## **Access Compliance Report Public Rights-of-Way** (Curb Ramps)

Intersection ID: 48423 Main Street: EVANTON LOCH RD **Cross Street: BEDLINGTON RD** Location: SE **ADA ID: F6AAF308561A** Ramp Type: BlendTrans1 Initial Pass/Fail: Fail **Overall Compliance: No Severity Score:** 12.5

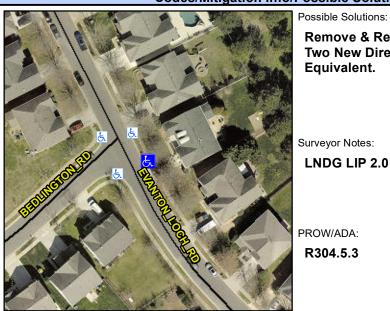
Surveyor Notes:

**LNDG LIP 2.0**

R304.5.3

Remove & Replace Curb Ramp With Two New Directional Ramps or Equivalent.
